HCCSC - HNHS Window Replacement

Project # 2025.0012

ADDENDUM NO. 4

DOOR #309 – Sidelight

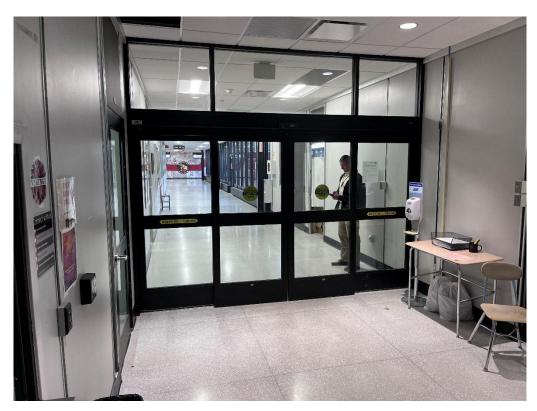
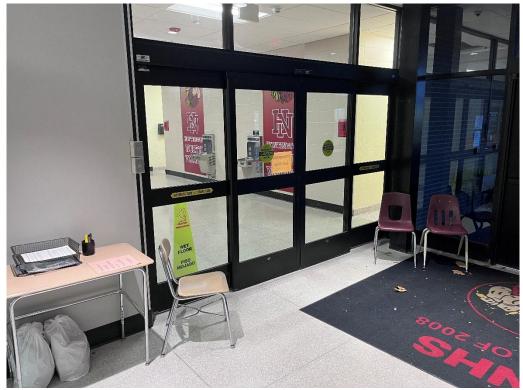
Description: CLARIFICATION - Contractor shall provide and install 3M Safety Film with IPA sealant at the

sidelight of Door #309 only. See [ADDENDUM #4] EXHIBIT #2 – DOOR #309 SIDELIGHT.
